Subject: Docket No. 72-1015

Submittal of Supplemental Information to the Response to RAI-2 for the NAC-UMS<sup>®</sup> Universal Storage System Amendment for Maine Yankee Atomic Power Company Site Specific Spent Fuel (TAC No. L22979)

**SUPPLEMENTAL INFORMATION TO RAI-2 RESPONSE**

**MAINE YANKEE AMENDMENT  
NAC UNIVERSAL STORAGE SYSTEM (NAC-UMS®)**

Figure 4.4.1.8-1 Three-Dimensional Transfer Cask and Canister Model

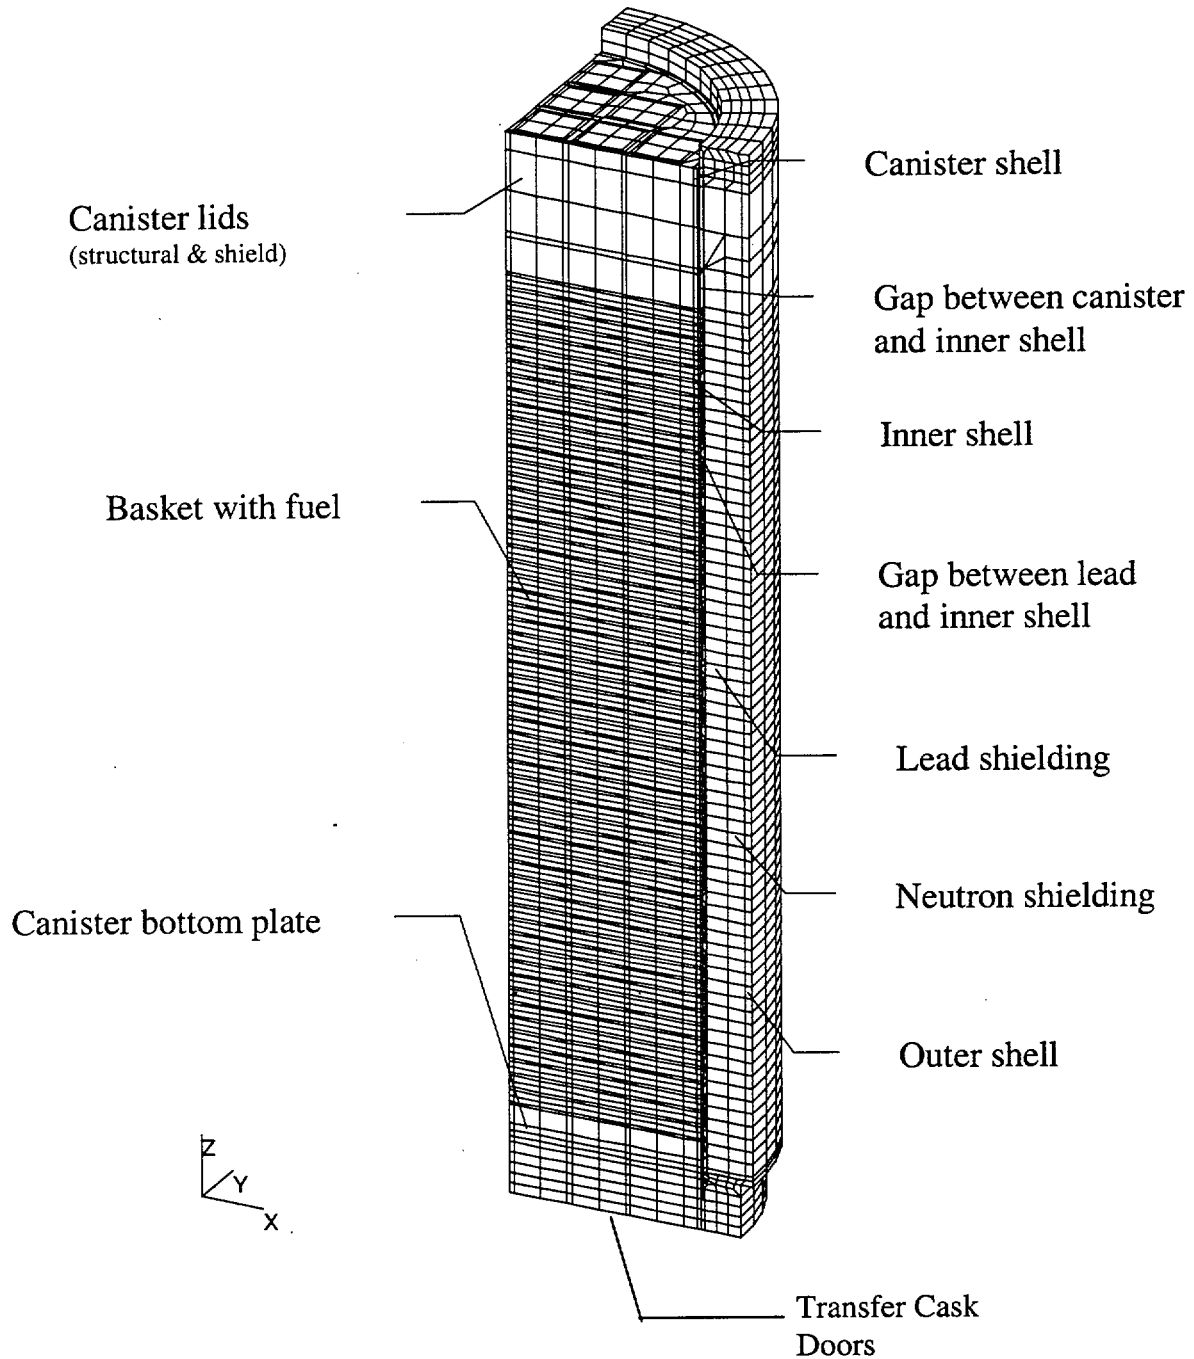
- Clarify the table presented in the RAI 4-6 Response to identify the heat load distribution used for the 20 non-central basket locations, i.e. it appears to imply an averaged heat load distribution at those locations;

- Clarify the description of the modeled application of a linear heat load distribution in the radial direction so that the staff can ascertain what heat loads have been analyzed for all of the possible spent fuel configurations; and

- Provide adequate information to demonstrate that the heat load and fuel loading configurations analyzed bound those that will actually be loaded for UMS standard burnup fuel and Maine Yankee high burnup fuel for normal loading conditions and post-LCO ACTION (24-hour in-pool cooling) conditions.

The evaluations of the reduced heat load/fuel loading configurations are performed using a new, more detailed ANSYS 3-D quarter-symmetry finite element model of the transfer cask/canister/basket. (A 2-D model was used in the previous analyses.) The specific heat load is modeled at each fuel assembly position in the basket in the 3-D model. The loading configurations evaluated consider the maximum number of design basis (0.958 kW) fuel assemblies allowed in a canister for a specific total canister heat load. The design basis fuel assemblies are considered to be loaded from the center of the basket outward for standard burnup fuel and similarly for high burnup fuel, except that the high burnup fuel assemblies are restricted to the peripheral basket locations per Technical Specification Section B 2.1.3.

A three-dimensional finite element model is generated for the transfer cask with the loaded canister for the PWR fuel configuration, as shown in Figure 4.4.1.8-1. The model is used in Section 4.4.3.1 to evaluate the transfer operation for PWR fuel heat load cases with less than the design basis heat load of 23 kW (evaluated in Section 4.4.3). A quarter of the transfer cask, basket and canister is modeled due to the symmetry of the components and thermal loads. The planes of symmetry are considered to be adiabatic. The finite element model is comprised of SOLID70 and LINK31 radiation elements. The canister and its contents are modeled using the methodology described for the three-dimensional canister model for PWR fuel in Section 4.4.1.2.
